Service Bulletin

SUBJECT: Service Update for Inventory and Customer Vehicles
Turbo-to-Exhaust Manifold Joint May Relax
Expires with Base Warranty

MODELS: 2013 Cadillac ATS
2013 Chevrolet Malibu
Equipped with 2.0L Engine (LTG)

Subject: 13013B – Service Update
Turbo-to-Exhaust Manifold Joint May Relax
Revised Service Procedure

Chevrolet Malibu shown for illustration purposes, Cadillac ATS similar.

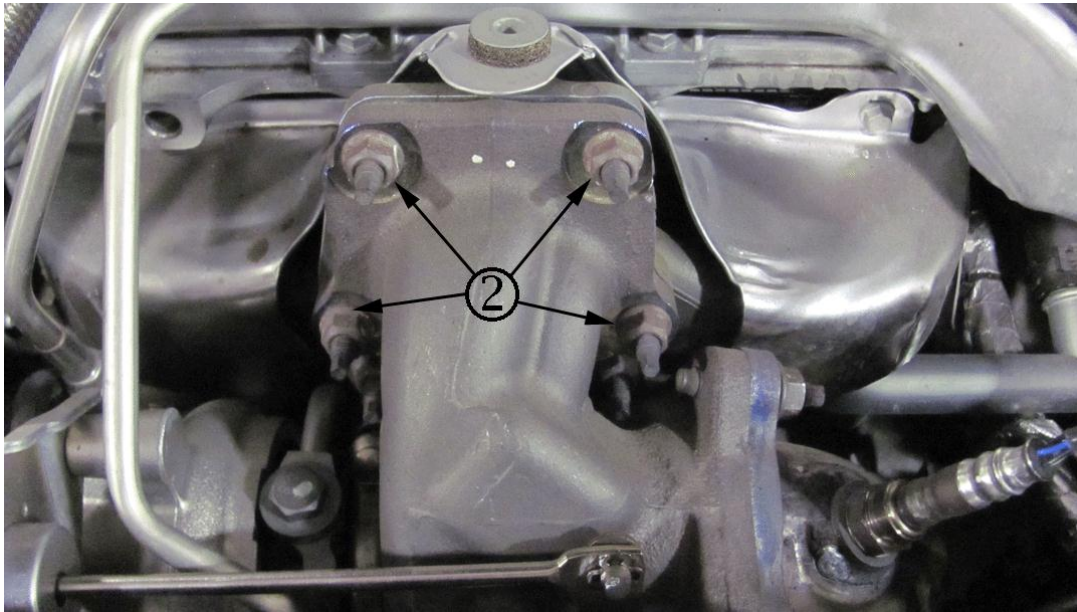
2. Locate the turbocharger exhaust heat shield (1).

3. Remove the turbocharger exhaust heat shield. Refer to *Exhaust Manifold Heat Shield Replacement (LTG)* in SI.

4. Loosen the four turbocharger-to-exhaust manifold nuts (2).
5. Tighten the four turbocharger-to-exhaust manifold nuts (2) to **30 Nm (22 lb-ft) + 90 degrees**.
6. Re-install the turbocharger exhaust heat shield. Refer to *Exhaust Manifold Heat Shield Replacement (LTG)* in SI.

7. Tighten turbocharger exhaust manifold heat shield fasteners to **9 Nm (80 lb-in)**.
8. Close the hood of the vehicle.
